CELIER AVIATION

Mast Bulletin Service Introduction

Modification of mast fixation to the fuselage.

Pic.1. Mast modification

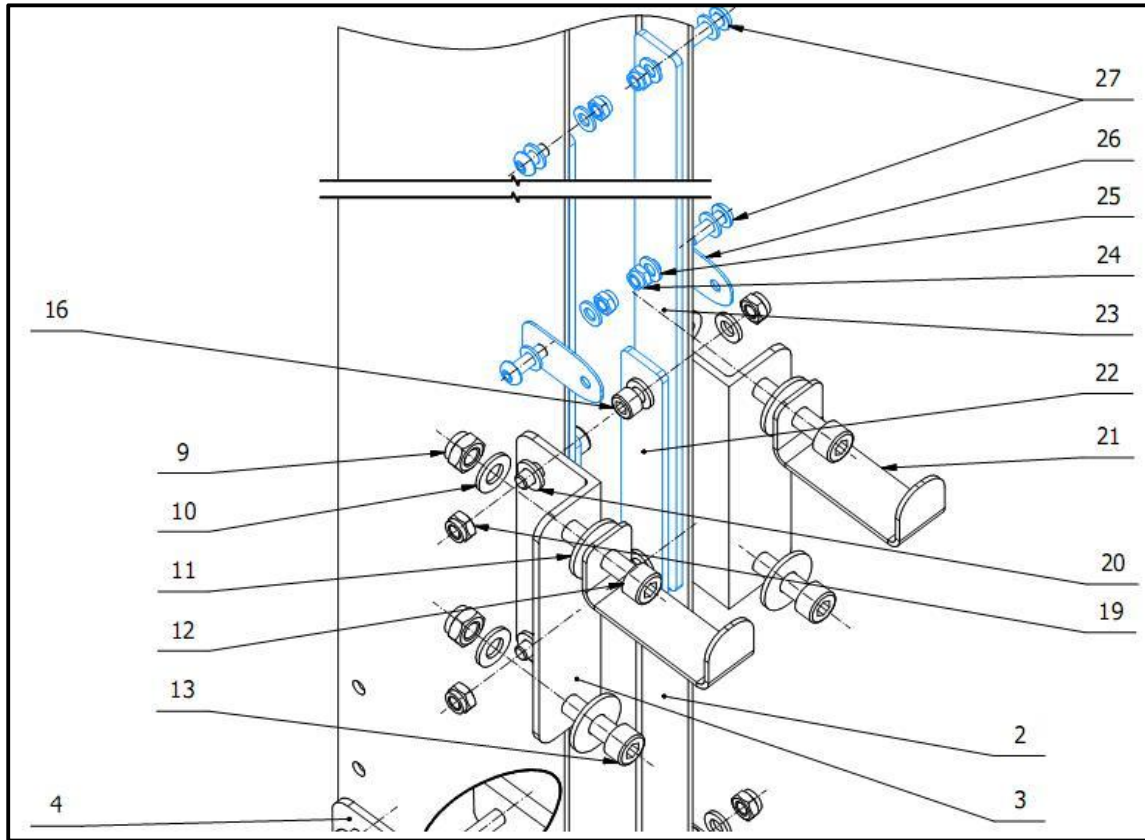
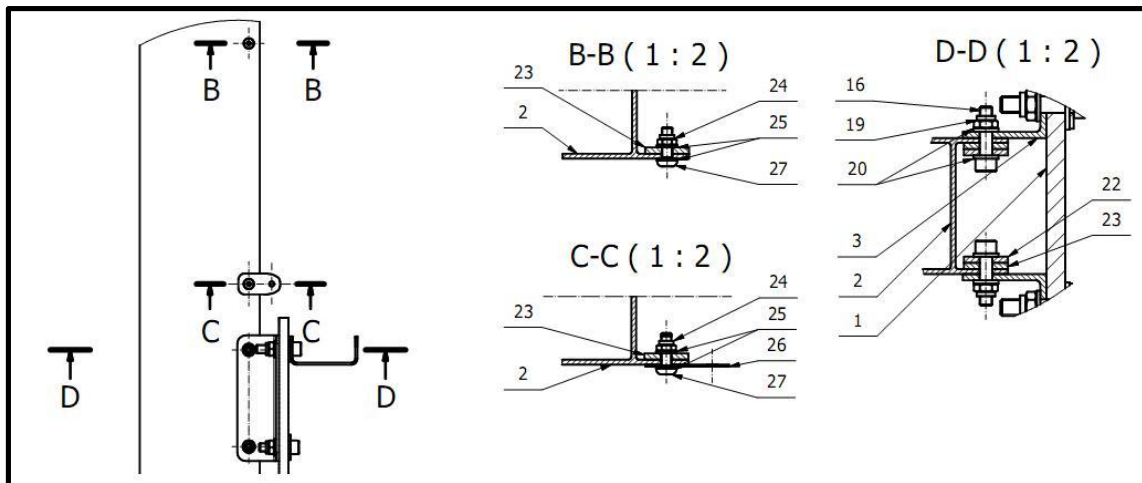
Due to have found masts showing an initial crack on external edges, we have decided to propose an upgrade and a reinforcement for the mast in the zone subjected to wear.

The upgrade, retains the possibility of this safety point, while offering more solidity in severe uses.

The upgrade kit is available immediately, please contact our spare part service to order it. Cost is 35€ plus transport.

Pic.4.Mast spoiler cut

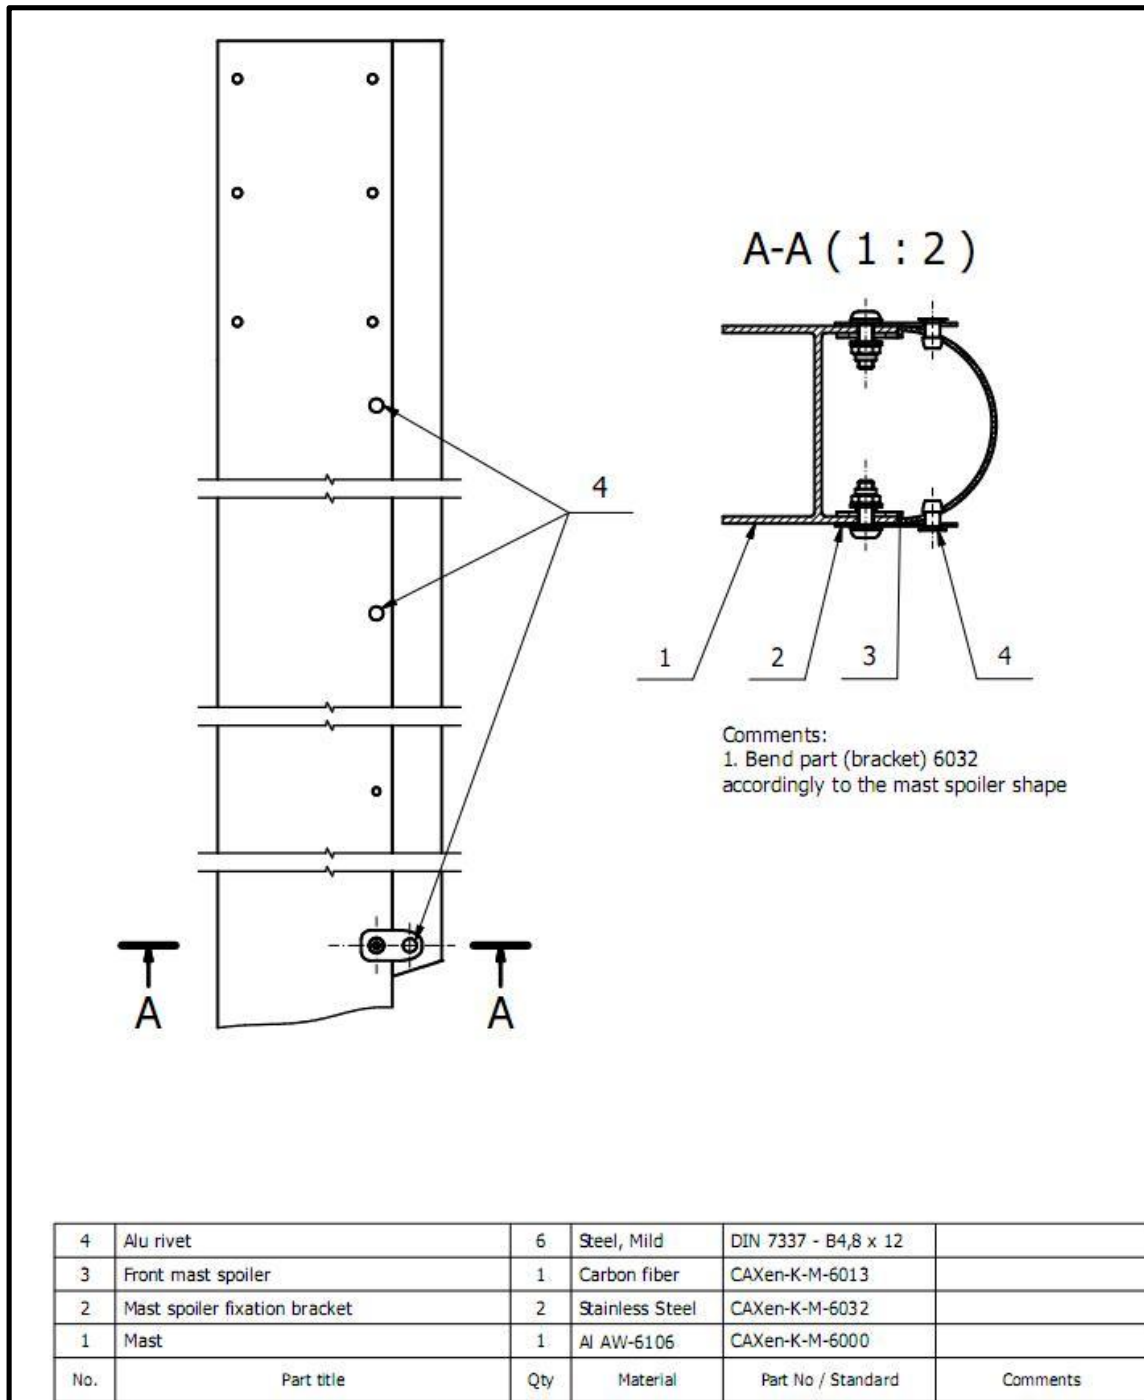
To fix front mast spoiler to the mast, cut it in accordance to Pic.4.
Then attach it to the mast and rivet it in accordance to Pic.5

Pic.7. Typical diagram of Von Mises Stress obtained in simulation.

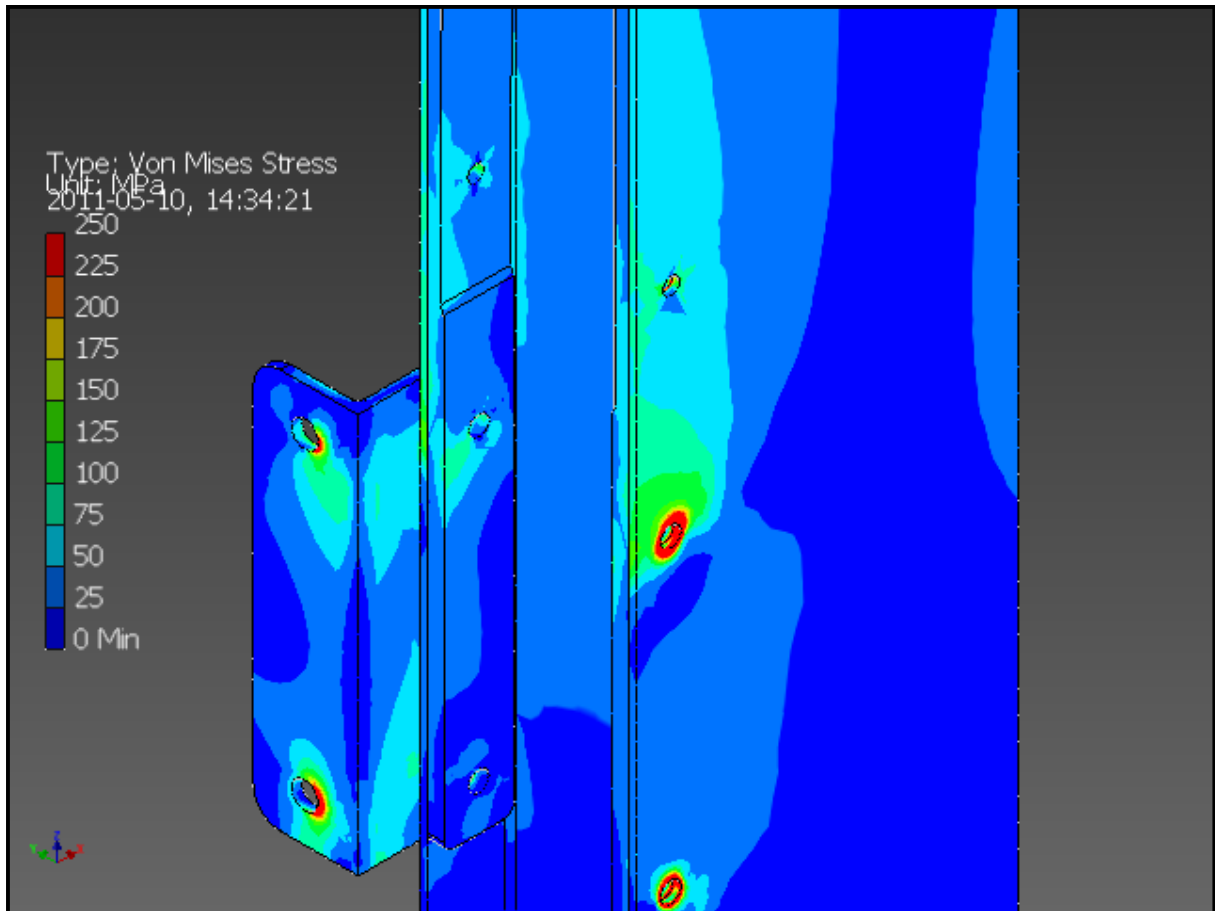
Two stress analysis were performed for new mast fixation and reinforcement.

First one considered Xenon gyroplane with MTOW= 450kg and the second one with MTOW= 560kg (Typical results presented below). In both cases simulation showed better results than without mast upgrade:

- Each simulation was performed for the load factor of 3,5 and safety factor of 1,5;
- Simulations were performed without the participation of additional parts that helps in load/vibrations distribution and stress concentration (such as cabin structure);

- The Ultimate Tensile Strength of the weakest material used is 250MPa and the stress do not exceed this value (*in a region that is to be taken into account- not in very close distance to the holes- influence of phenomena that are NOT perfectly described with the stress analysis*). Obtained values of stress give the margin of 30-10% above limit required by airworthiness rules and legislation.

- The original mast without reinforcement is still reliable structure.
- The proposed modification makes the mast structure stronger for: repetitive impacts, out of scale vibrations, overloaded gyroplane, usage of prerotator beyond its limitations. Reinforced version still retains the capacity for the mast to break upon strong blade flapping and/or ground strike protecting the occupants.

Pic.7. Original stress analysis of mast fixation.

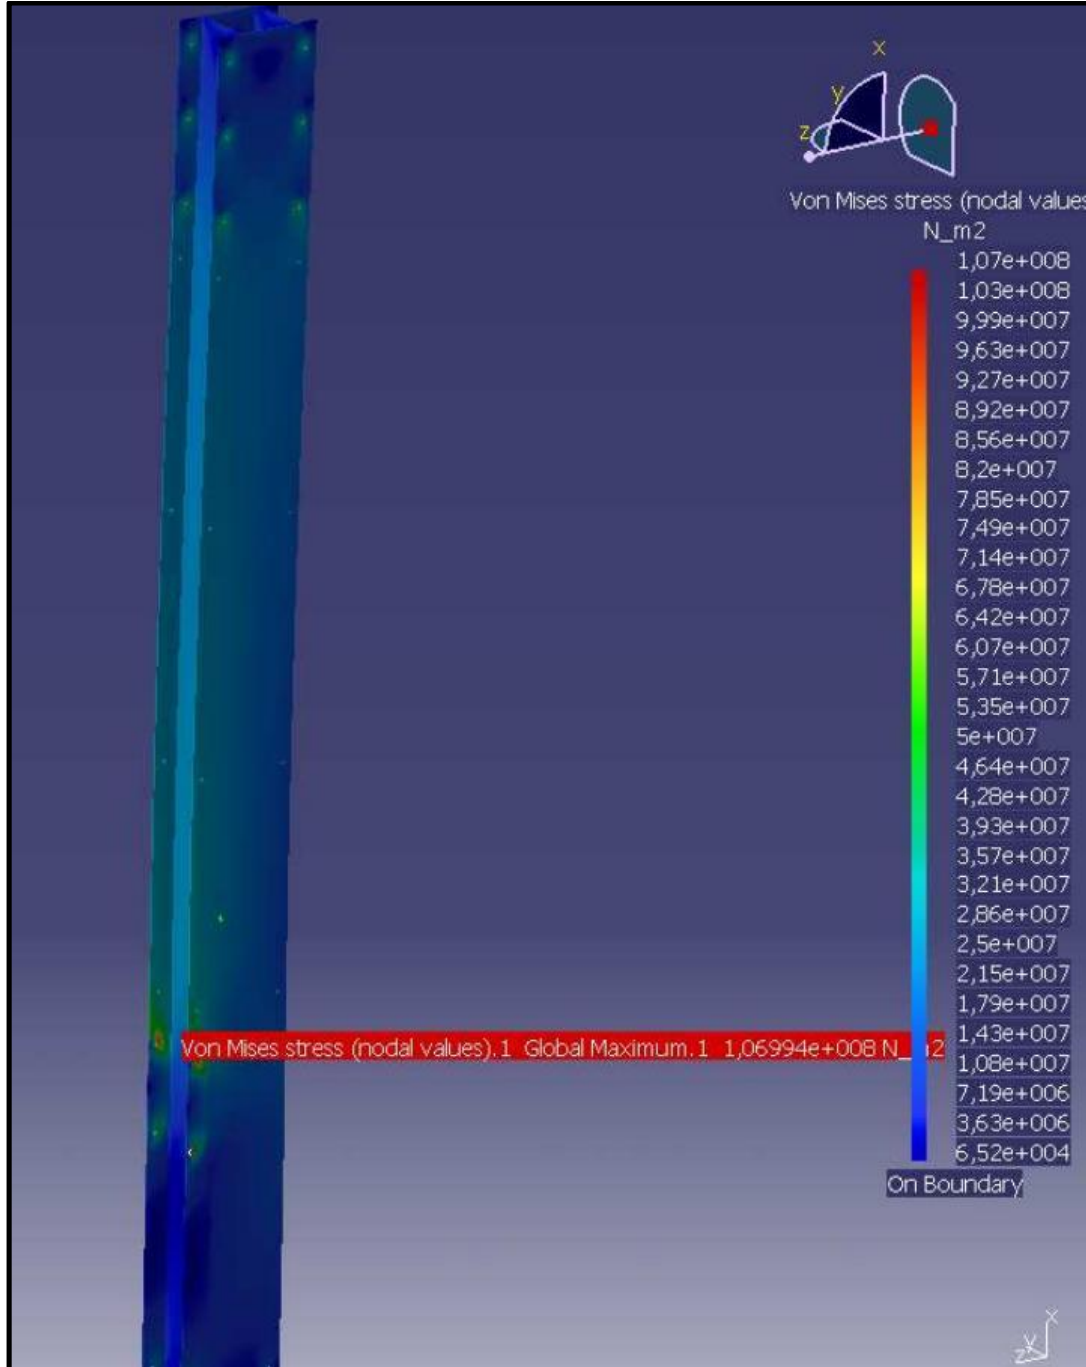
Original tested mounting of the Mast was done with a limit load of 525kg and load factor 3,5 multiplied by safety factor 2,1. Results have shown adequate strength in normal conditions of use (Pic.7).
